TOWN OF CORTLANDT PLANNING BOARD

Planning Board Work Session & Meeting Tuesday October 6, 2026

RE: **PB2026-12 - 44 Regina Avenue – Site Development Plans Self Storage**

LaBella has performed a review of the submittal for "Site Development Plan For Cortlandt Self Storage, LP" located at 44 Regina Avenue, Cortlandt Manor, New York.

SITE DEVELOPMENT PLAN	
AMENDED SITE DEVELOPMENT PLAN FOR CORTLANDT SELF-STORAGE, L.P.	
LOCATION: REGINA AVENUE TOWN OF CORTLANDT, NEW YORK	
SHEET 2 OF 6	SP-1.2

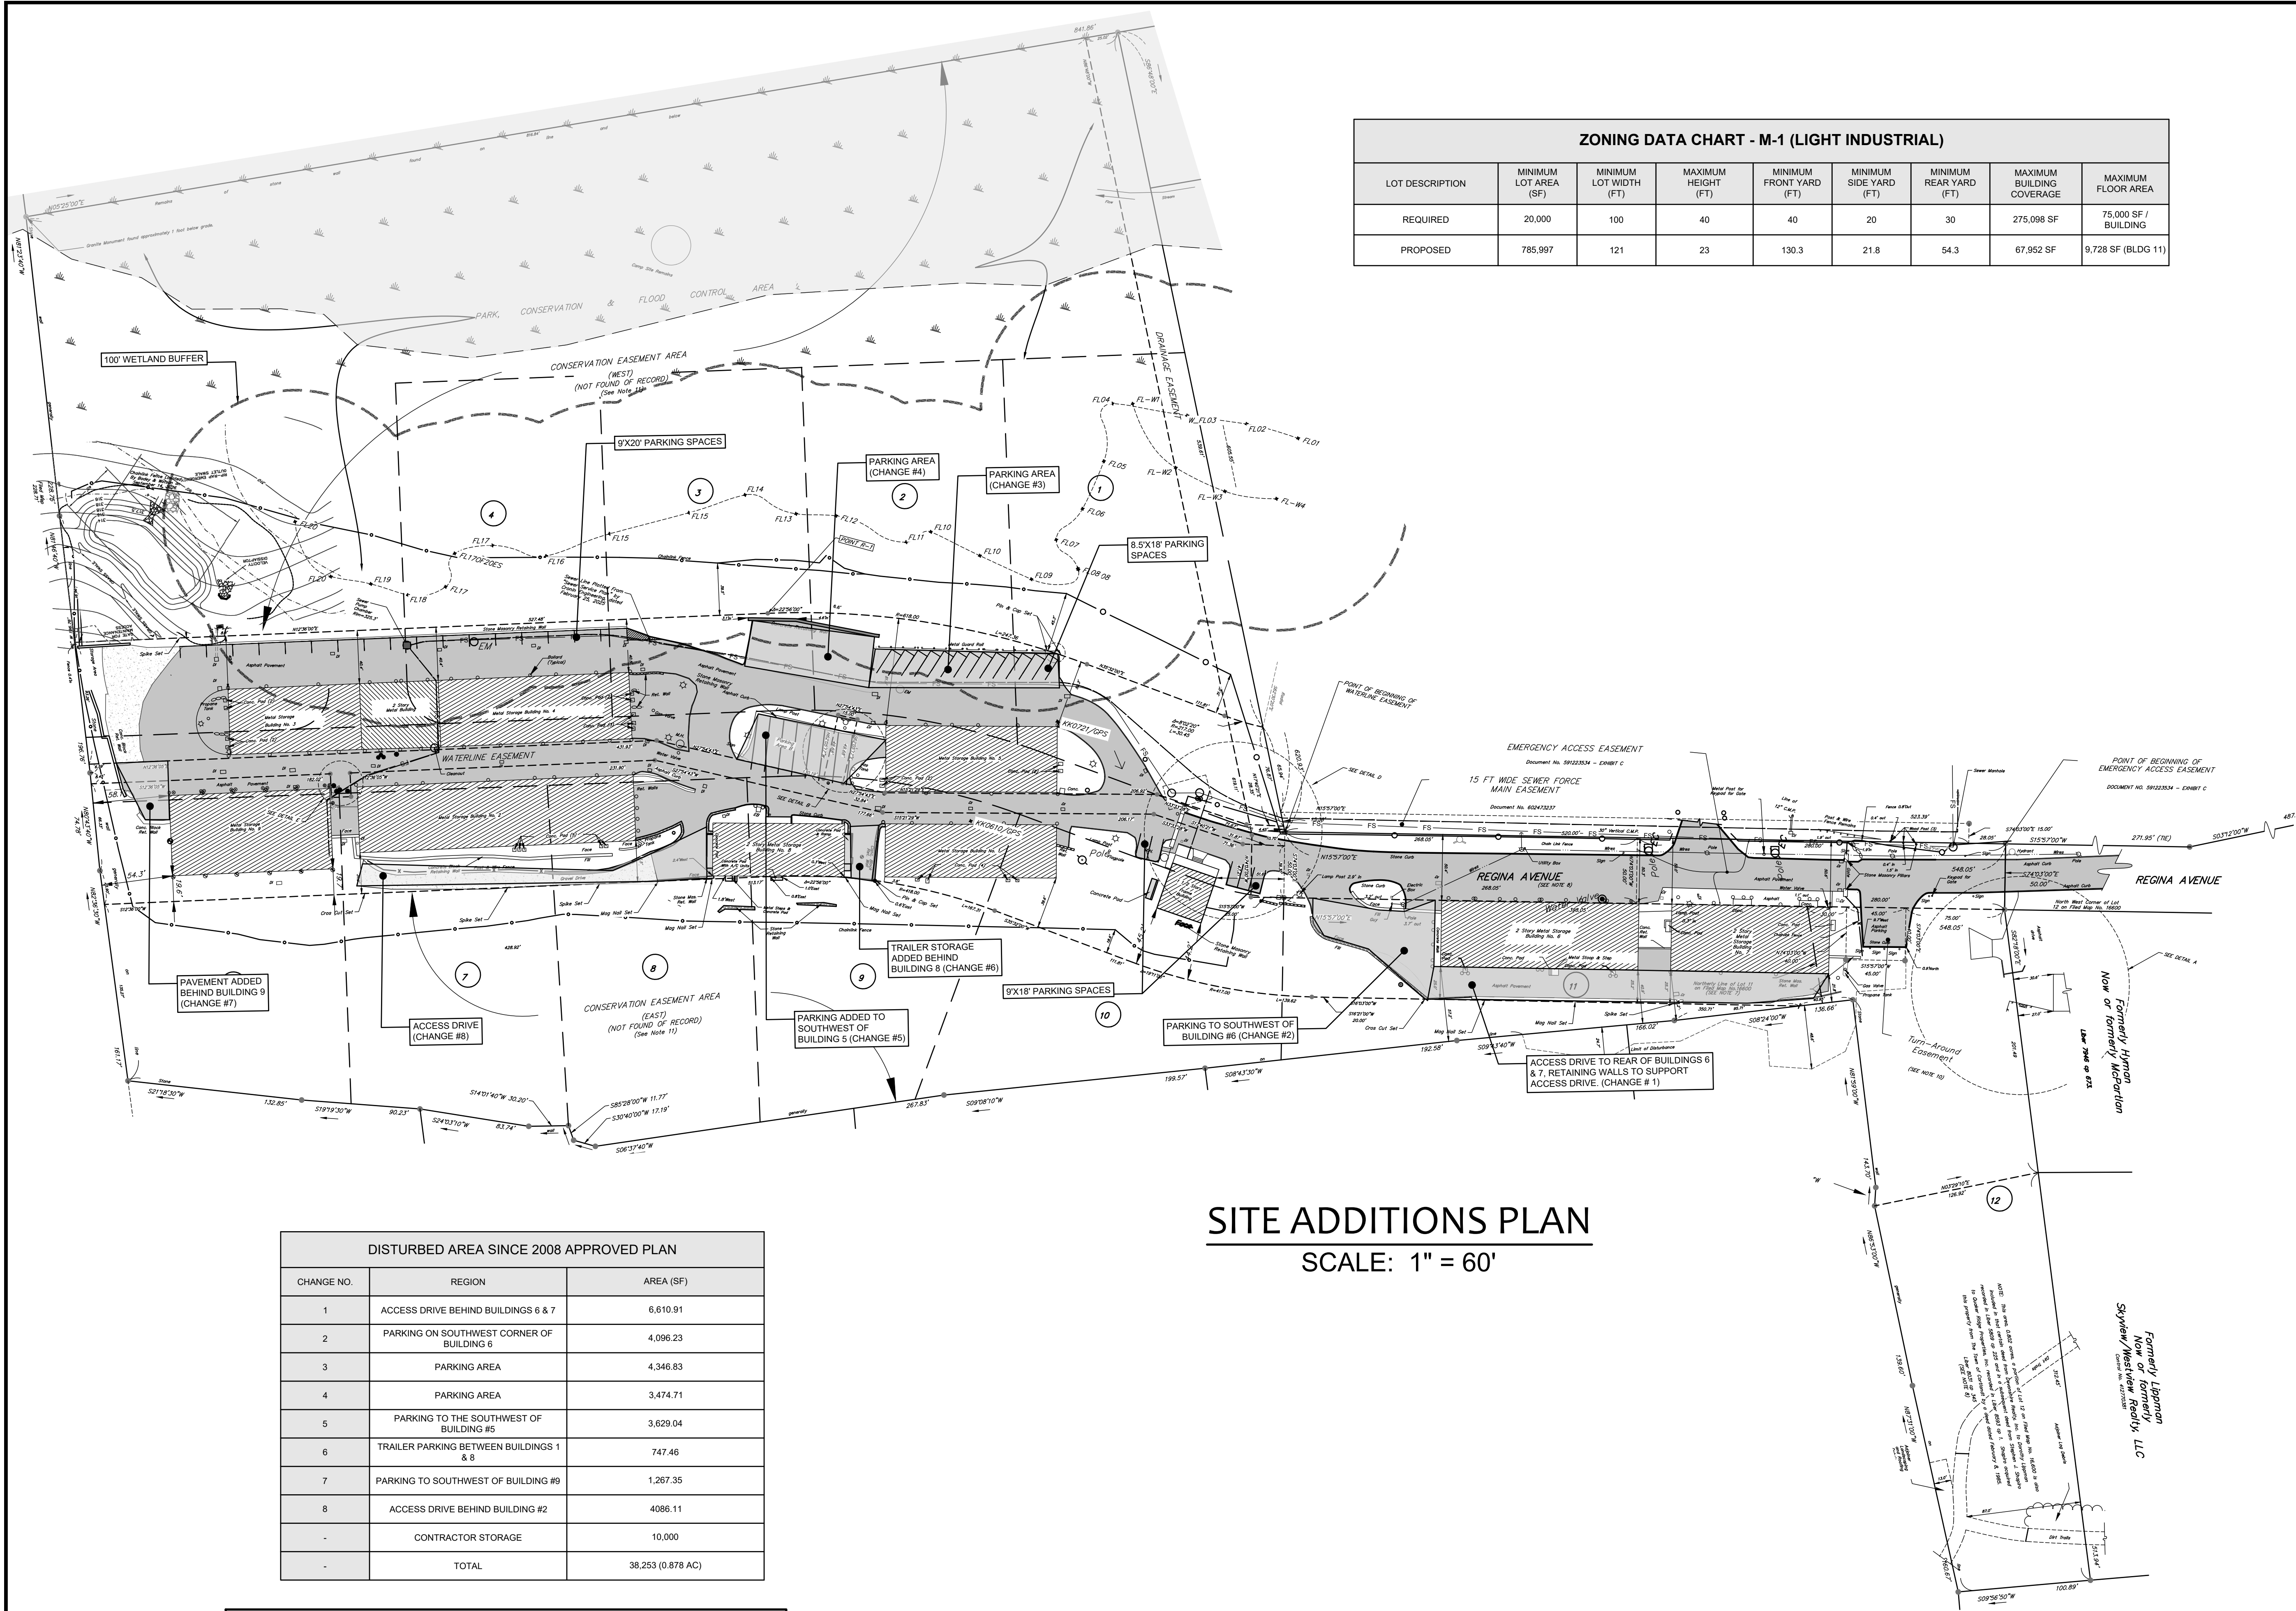
1. The Planning Board Chairman requested physical barrier (i.e. fence) around the contractor yard area.
2. Clarify the necessity of 623 sf of asphalt and retaining wall shown to the north of the new building. It appears a majority of the retaining wall and proposed asphalt (623 sf) to the north of the new building can be removed and a single 5-foot-wide access to the doors can be provided.

3. Identify points of door access to the proposed facility.
4. Provide a note on the plan indicating no exterior equipment storage or container storage is permitted outside of the areas designated as contractor storage and no outdoor repair of equipment is permitted.

5. Show relocated sanitary force main, drainage pipe, and drainage structures, footing drains, as well as proposed drainage infrastructure (including roof leaders and means of conveyance).

6. Provide a note on the plan that sanitary sewer force main and drainage piping to be relocated prior to building construction. Also note, sanitary force main is to be pressure tested following relocation in the presence of a Town of Cortlandt Department of Technical Services Representative and Applicant's Engineer. A Professional Engineer shall provide a certification of said installation and testing to the Town.

7. Provide additional capacity for the increase in impervious areas within the stormwater management basin compared to the original site plan. Note the basin shall be restabilized with topsoil, seed, and mulch.

8. Please confirm if the area of total disturbance associated with the additional improvements identified in Administrative Comment 1 and the proposed project exceed the one acre threshold and thus require a SWPPP under the NYSDEC Redevelopment criteria.

9. Sheet SP1.1 indicates material storage on-site but is not shown on Sheet SP-1.2. Material storage areas shall be shown along with mechanism of containment to prevent sediment runoff.

10. Show not only spot elevations but proposed contours around the building.
11. Provide new invert at drop inlet with rim 328.9 receiving the new 15-inch drainage pipe.

14. Number all buildings.
15. Add a note indicating the conservation easement shall be field staked by a NYS licensed surveyor prior to Building Permit Issuance. At no point shall the conservation easement be encroached upon.

17. Provide a safety plan on how equipment moves from one side of the site to the other without interfering with the customers accessing the storage buildings.

18. List the exact equipment proposed to be onsite in the contractor's yard.
19. Clearly indicate employee vs customer parking.
20. Consider eliminating door locations on Sheet FP-3.1 and Sheet FP-3.2 in the front and rear of the building to eliminate the needs for stairs in the rear and retaining wall and ramp in the front. Otherwise show the necessary improvements for Planning Board review and consideration.

21. As indicated at the September Planning Board meeting, please add a note that no storage of aggregate material will take place within the contractor storage area.

Response: The above referenced notes have been added to sheet SP-1.2 of the site plan.

CD-2.1

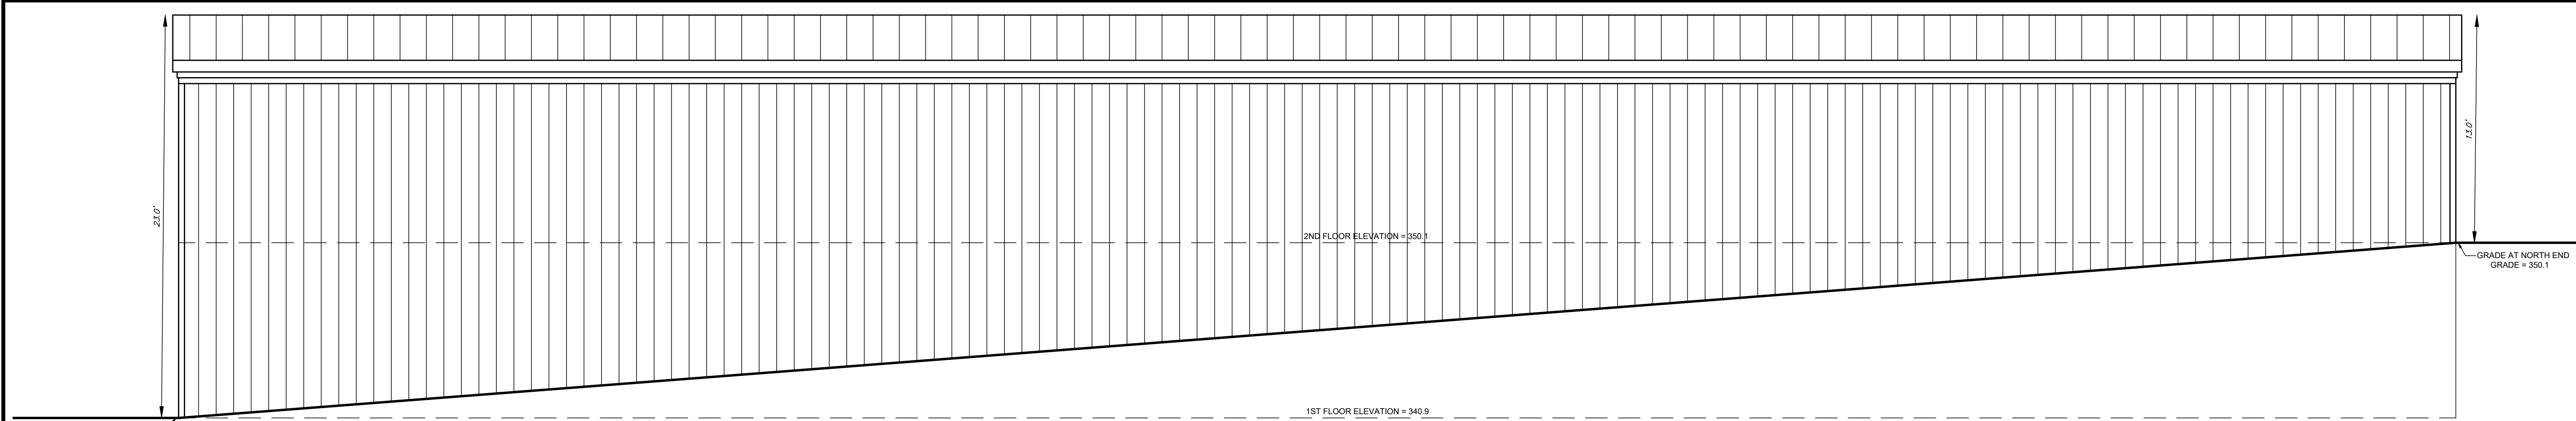
1. Multiple details for sewer installation beneath pavement are provided. Select one and remove the others.
2. Driveway asphalt section differs from trench replacement details. Please clarify and provide consistent asphalt sections.

FP-3.1

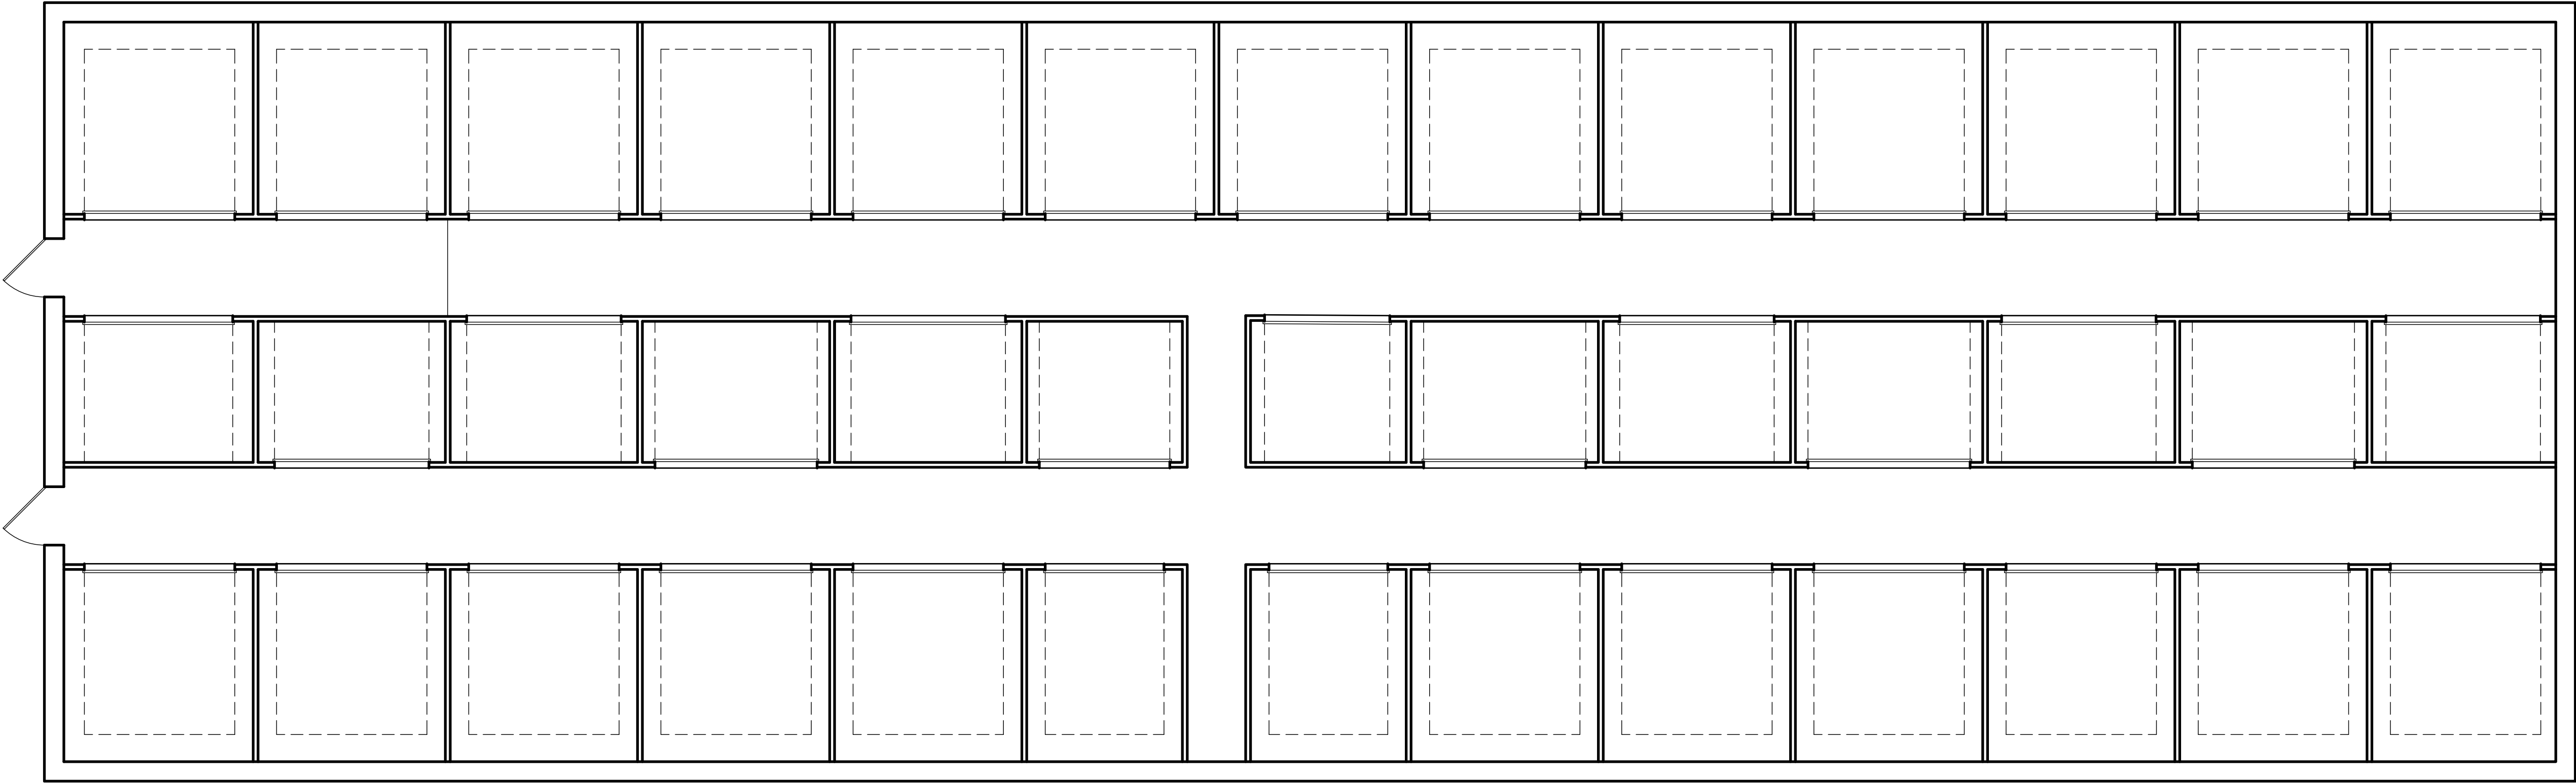
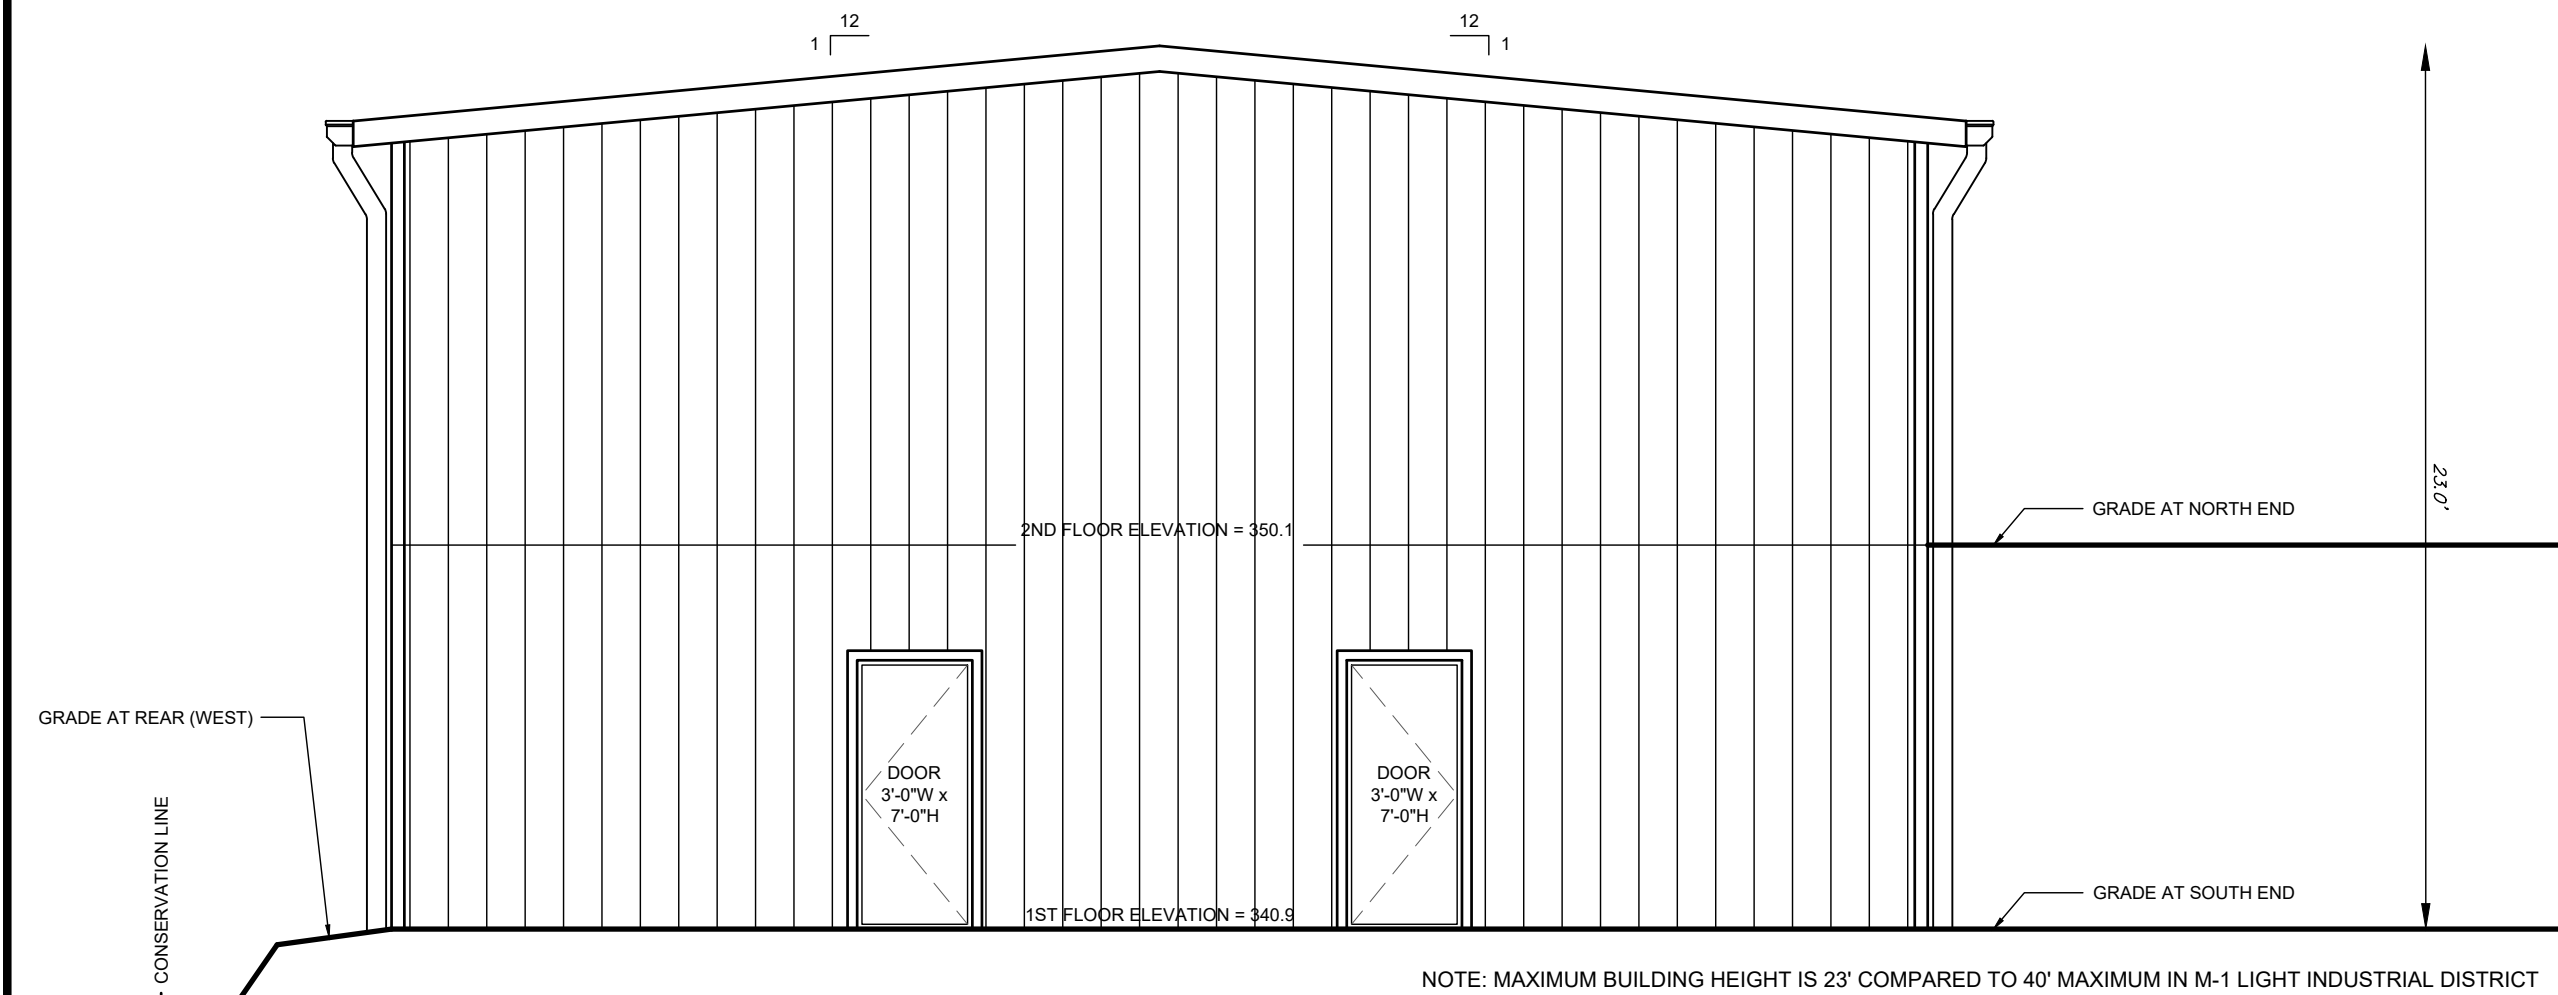
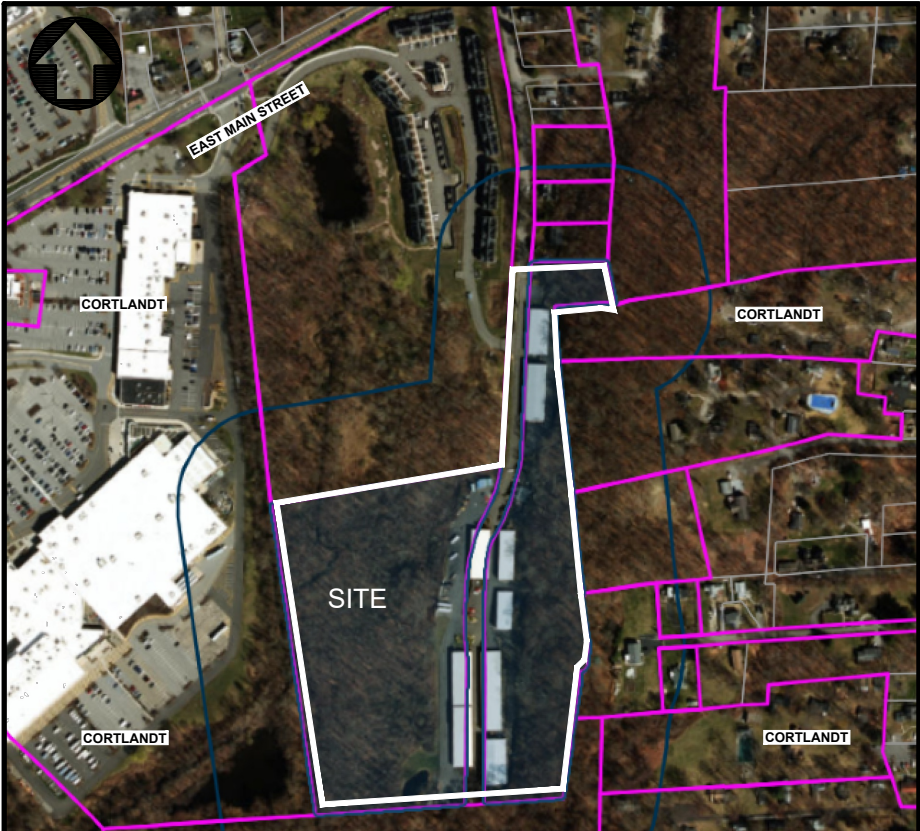
- c. *Clarify whether the proposed new self-storage building also includes office space. The Building Chart on sheet SP-1.1 says the proposed use of the building is "self-storage and office" but the floor plans on sheets FP-3.1 and FP-3.2 do not appear to indicate any office use.*

20. *Consider eliminating door locations on Sheet FP-3.1 and Sheet FP-3.2 in the front and rear of the building to eliminate the needs for stairs in the rear and retaining wall and ramp in the front. Otherwise show the necessary improvements for Planning Board review and consideration.*

Response: The proposed height of Building 11 at both north and south elevations has been added to sheet FP-3.1 of the plan set.
